13 SUB2016-00003

COTTAGE HILL PLACE ESTATES SUBDIVISON

APPLICATION NUMBER 13 DATE February 18, 2016

DETAIL SITE PLAN

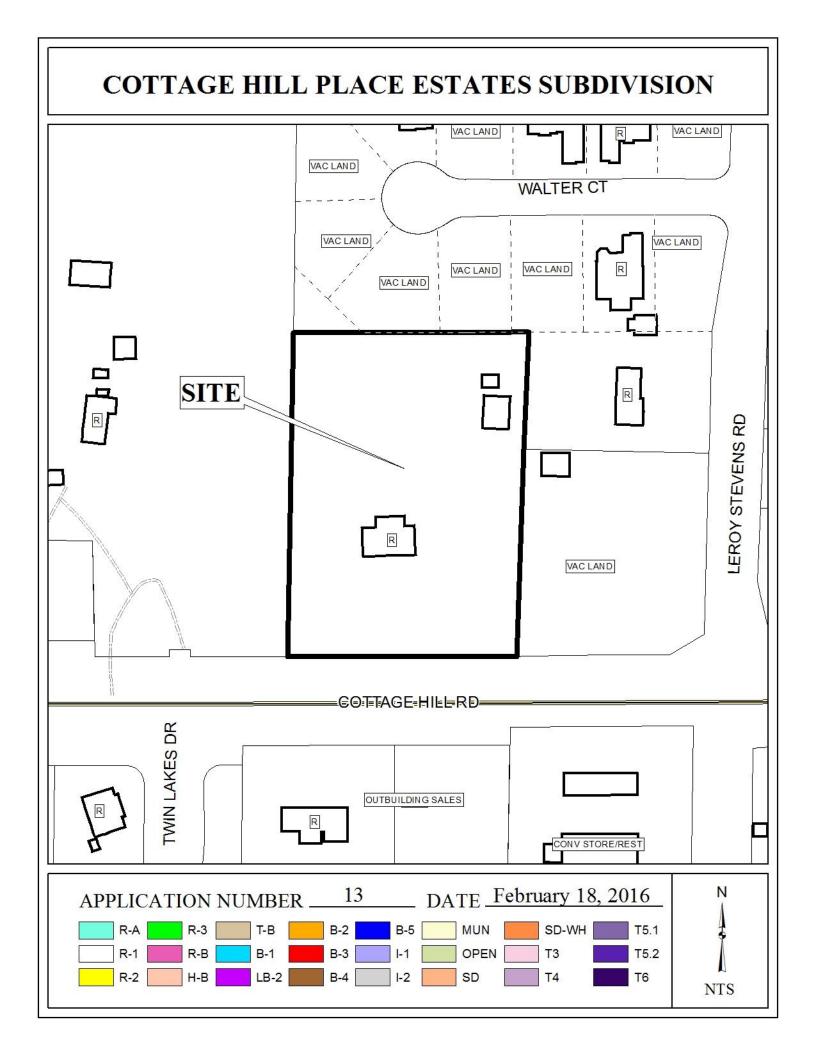
The proposed lots front Cottage Hill Road, a planned major street as shown on the Major Street Plan Component of the Comprehensive Plan. This street requires a 100' right-of-way width; however, the existing right-of-way width is depicted as 140', with the property line shown as 70' from the centerline, as such, no dedication should be required.

The 25' minimum building setback line is depicted on the preliminary plat and should be retained on the Final Plat, if approved.

In accordance with the Subdivision Regulations, both proposed lots appear to exceed the minimum lot size requirements; however, the lot sizes are only given in acres. If approved, the Final Plat should be revised to reflect the lot size in both square feet and in acres.

It should be noted that the proposed Lot 2 does not meet the standards for width-to-depth ratio. Section V.D.3. of the Subdivision Regulations states that the lot depth should not exceed 3.5 times the width of the lot at the building setback. As proposed, Lot 2 will be 109.9'± wide at the setback line and 448.5'± deep, resulting in a lot that is approximately 63.8'± deeper than would normally be allowed. The proposed interior lot line could be relocated to comply with the requirements of Section V.D.3. of the Subdivision Regulations, but the lot line would bisect an existing dwelling on the proposed Lot 1. Furthermore, while there are no legal lots of record in the area that exceed the standards for width-to-depth in the area, there are several metes-and

bounds parcels that do, making a waiver of Section V.D.3. of the Subdivision Regulations appropriate.

As a means of access management, that the proposed Lots 1 and 2 are limited to the existing curb-cuts to Cottage Hill Road, with any changes to the size, design, and location of the existing curb-cuts to be approved by Mobile County Engineering and conform to AASHTO standards. This note is depicted on the preliminary plat and should be retained on the Final Plat, if approved.

This site is located in the County, therefore any lots which are developed commercially and adjoin residentially developed property must provide a buffer, in compliance with Section V.A.8. of the Subdivision Regulations. A note is depicted on the preliminary plat and should be retained on the Final Plat, if approved.

Based upon the preceding, this application is recommended for Tentative Approval, with a waiver of Section V.D.3. of the Subdivision Regulations, subject to the following conditions:

- 1) Retention of the 25' minimum building setback line;
- 2) Revision of the lot size information to be depicted in both square feet and in acres;
- 3) Retention of the note on the Final Plat stating that Lots 1 and 2 are limited to the existing curb-cuts to Cottage Hill Road, with any changes to the size, design, and location of the existing curb-cuts to be approved by Mobile County Engineering and conform to AASHTO standards.;

- 4) Placement of a note on the Final Plat stating: (*This site is located in the County, and therefore any lots which are developed commercially and adjoin residentially developed property must provide a buffer, in compliance with Section V.A.8. of the Subdivision Regulations.*);
